DESIGN RESPONSE

3	2019 05 03 ISSUED FOR COV CLARIFICATION
2	2019 02 28 RE-ISSUED FOR DEVELOPMENT PERMIT
1	2018 12 21 ISSUED FOR DEVELOPMENT PERMIT
Revisions	YYYY-MM-DD

1468 ALBERNI

Urban Agriculture

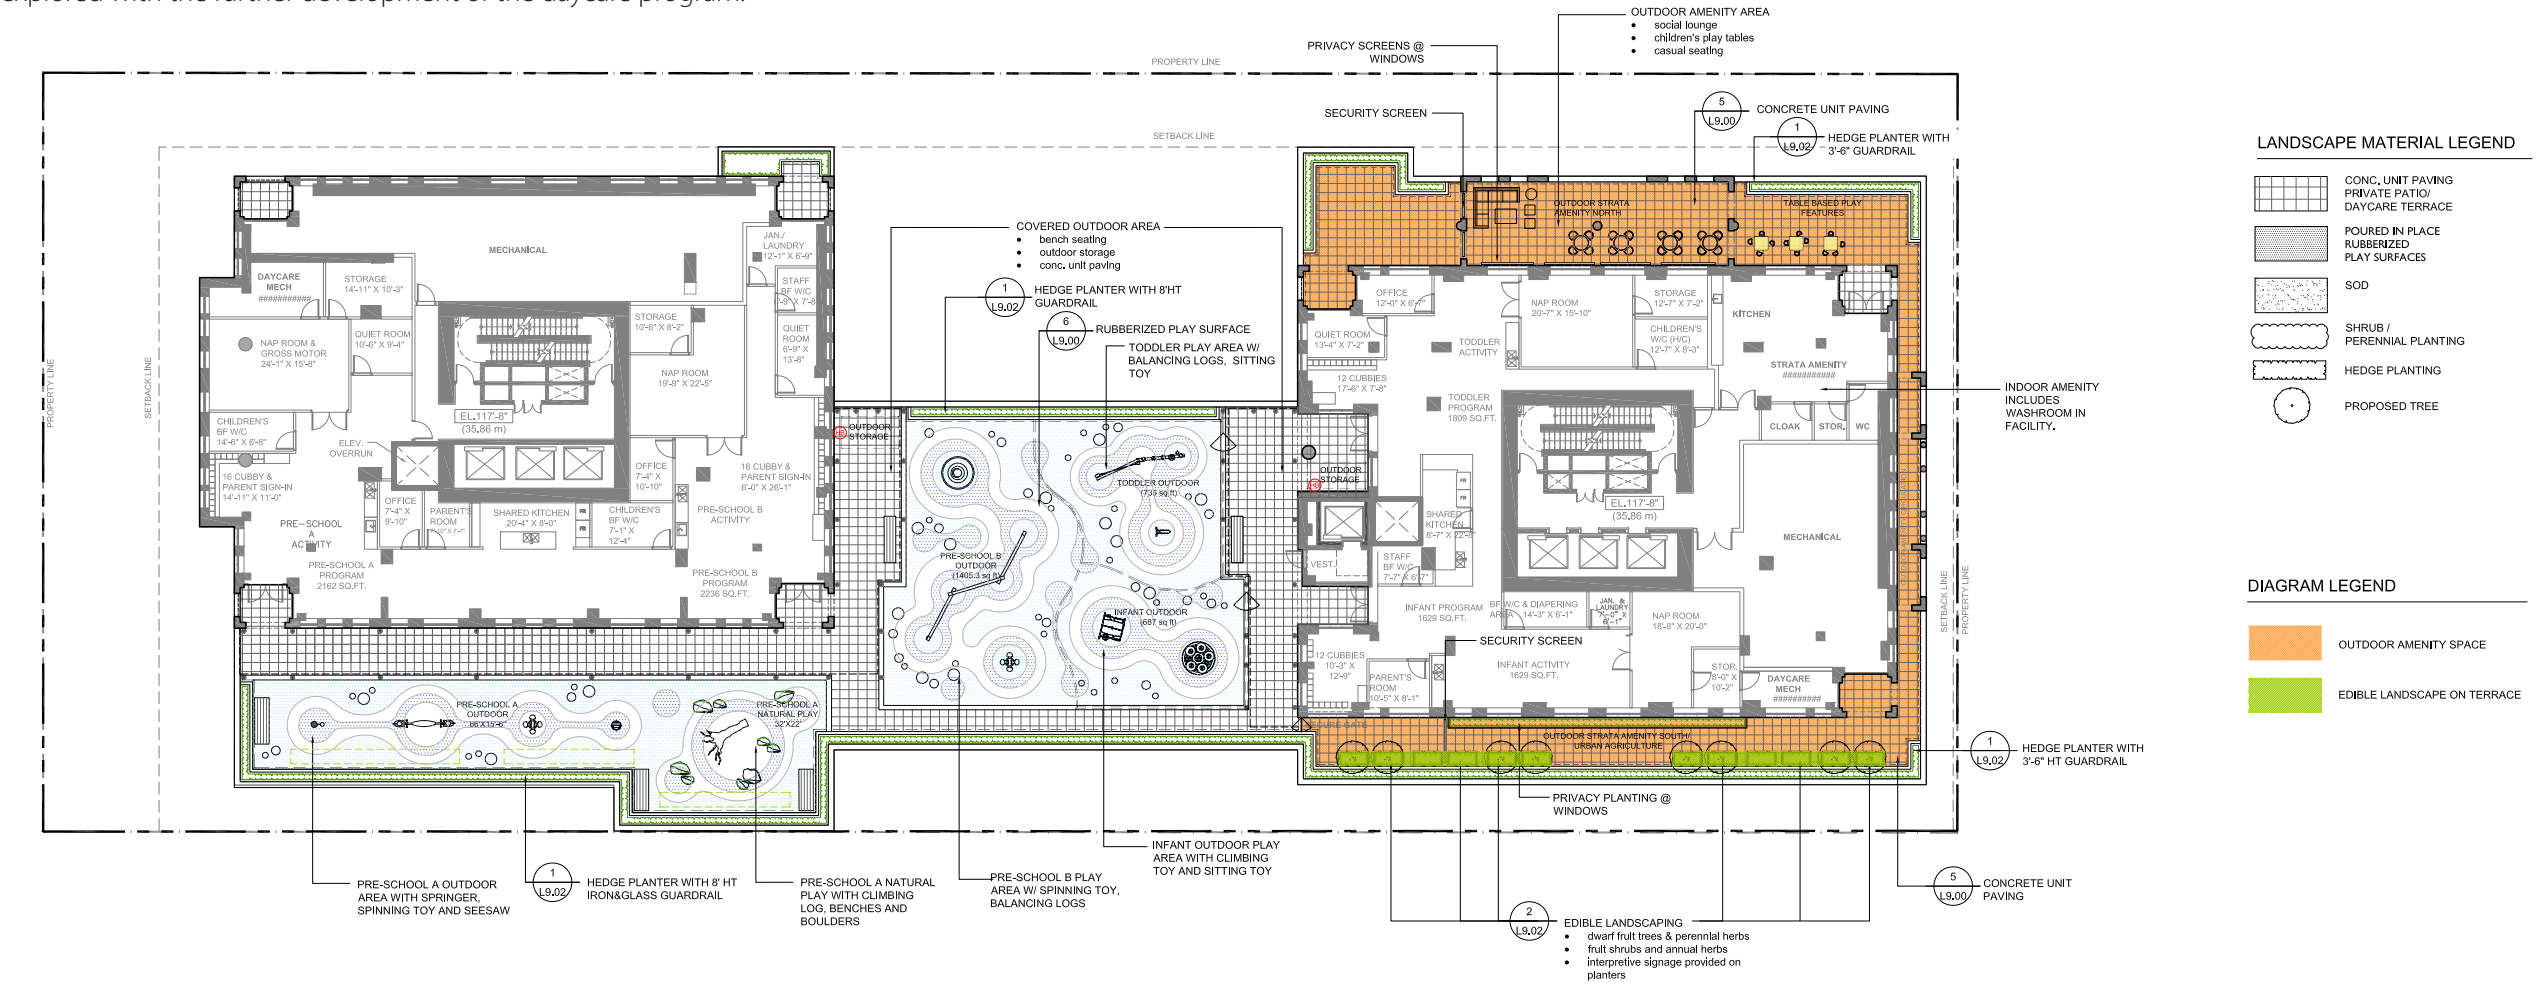
10. Design development to provide direct circulation to edible landscaping without conflicting with other uses such as the child day care facility.

A series of raised planters with dwarf fruiting trees and edible underplantings have been provided on the south facing terraces of Level 7 associated with the residential amenity. Additional opportunities will be explored with the further development of the daycare program.

A direct outside route is provided from the Level 7 amenity space to the edible landscape/urban agriculture located on the south side of the podium. See Architectural drawing DP213.
